PLANNING & ZONING BOARD STAFF REPORT

2419 North Federal Highway

Meeting	File No.	Application Type
May 18, 2026	2025-213-SPR-WAI-LV4 2025-214-USE-PZB	Level 4 Site Plan; Conditional Use, For Free Standing Multiple-Family Housing
Property Owner	Authorized Agent	
Ultra Luxury Townhomes, LLC	Jeffrey Costello, AICP JC Planning Solutions

LDR Section 4.6.18, Architectural Elevations and Aesthetics

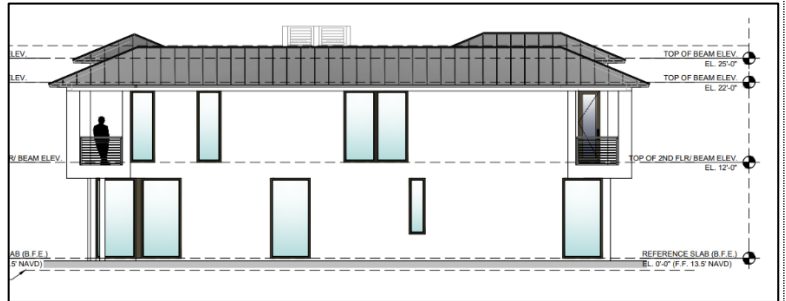
The proposal is identified as Contemporary Modern Architectural Style. The architectural design uses a neutral color palette, grey metal roofing, wood cladding accents, recessed balcony areas, and façade articulation along North Federal Highway and the internal drive aisles. These elements provide visual movement and help reduce the apparent length and mass of the townhouse-type buildings where the elevations are most visible from the public frontage and from internal circulation areas.

The strongest architectural treatment is provided along North Federal Highway and along the internal drive aisle frontages. These elevations include more defined entries, balcony recesses, shifts in wall plane, and material changes. However, some side and rear elevations do not carry the same level of articulation, material treatment, or façade depth. This is most relevant where those elevations face adjacent properties or contribute to the perceived edge of the development. The project would benefit from carrying key design elements around the buildings so that side and rear elevations do not appear secondary to the frontage and driveway-facing elevations.

The Board should consider whether the proposed elevations, as designed and conditioned, satisfy the criteria in LDR Section 4.6.18. In particular, the Board should consider whether the architectural treatment contributes to the image of the City, whether the side and rear elevations provide sufficient design quality, whether the repetitive townhouse rhythm is adequately mitigated, and whether the project remains harmonious with the evolving character of the North Federal Highway corridor and the adjacent residential edge.

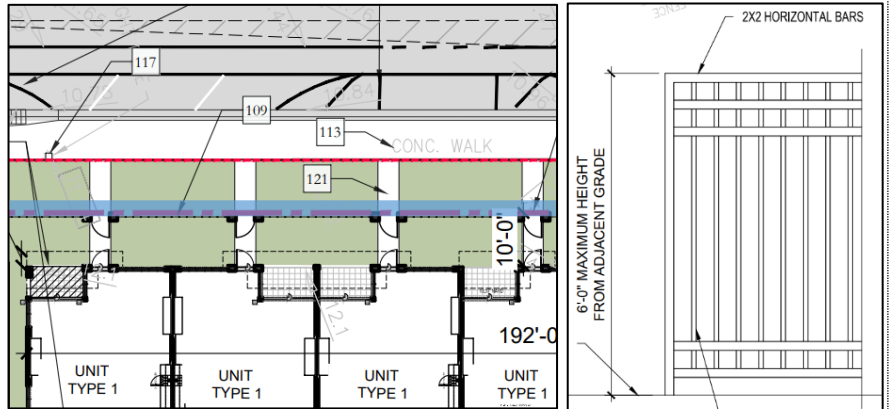
The intent of the townhouse design standards, such as the four-foot offset requirement, is to prevent long rows of repetitive design, reducing the overall mass, and articulating each townhouse unit (shown in blue to the right). Rather than offsetting each townhouse unit, the project proposes to provide a four-foot articulation within each unit (shown in purple to the right).

The offset requirement applies to both the rear and front of the structure; the structures along North Federal Highway appropriately articulate the townhouse mass both to the front and rear similar to the intent of offsetting the townhouse units (shown to the right). All the facades facing the driveways have this four-foot articulation within each townhouse unit, breaking up the overall massing; several rear and side elevations, particularly along the south and east edges, do not provide the same level of articulation as the driveway-facing elevations.

The Board should consider if the proposed four-foot articulation within each unit adequately meets the intent of the offset requirement, or whether the lack of rear and side articulation weakens the request.

3. LDR Section 4.6.9(D)(6)(d): Drive Aisle Width

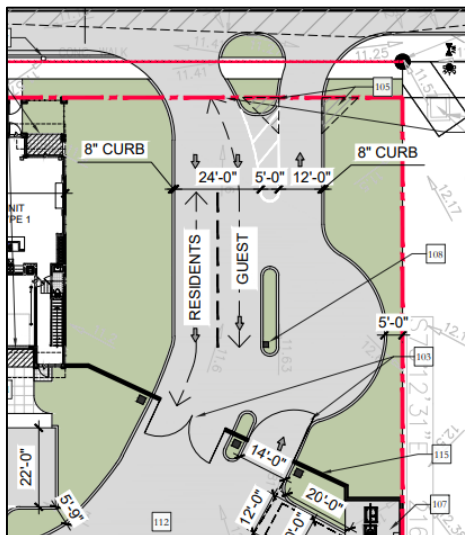
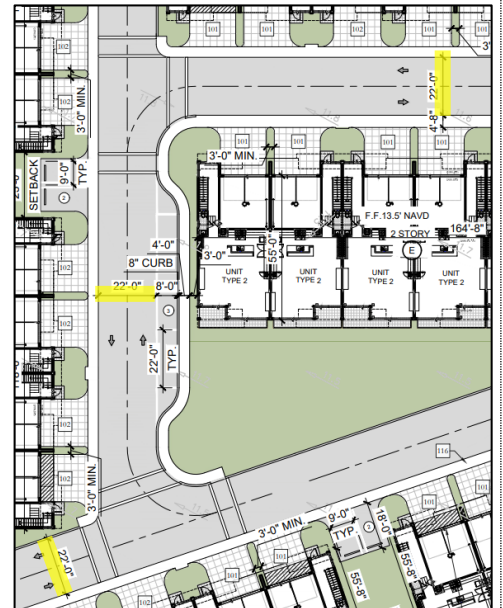
The project proposes 22-foot private drive aisles, whereas the code requires a minimum width of 24 feet. Drive aisle width requirements are established to ensure safe two-way circulation and adequate maneuvering for vehicles backing out of parking spaces. The applicant has proposed a maneuvering diagram that illustrates larger vehicles will be able to effectively maneuver through the site. However, the reduced width occurs in areas where parking is located on both sides, which may create conflict between parked vehicles, backing movements, service vehicles, and emergency access. Fire has also noted potential concerns if a fire truck blocks circulation while accessing a hydrant during an emergency.

The Board should consider whether the reduced drive aisle width will negatively affect maneuverability and safety within the development. The requested reduction applies only to private internal drive aisles and does not directly affect the public right-of-way.

6. LDR Section 4.6.2(B): Residential Building Separation

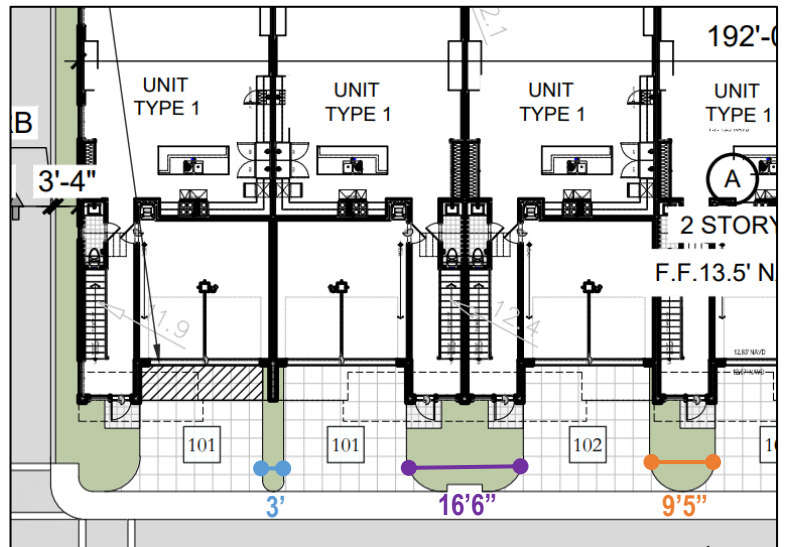
The LDR establishes regulations for the distance between residential buildings to provide adequate separation between structures to allow for light, air, and open space; and to provide for aesthetically pleasing design relationships among buildings which are constructed within a townhouse, apartment, or condominium residential development. The required distance separation is a function of the proposed length and height of the buildings, whereas the larger the building the more separation is generally required. Based on the dimensions of the proposed structures, a separation between buildings ranging from 32 feet to 38 feet would be required. The applicant instead proposes a distance of 25 feet between Buildings A, B, C and D, and 12 feet, 4 inches between Building E to the Recreational Center. This request has no impact on the perimeter setbacks.

The Board should consider whether the proposed building separation provides adequate light, air, privacy, and open space between buildings, or whether the site would benefit from fewer units or a revised layout with greater separation between structures.
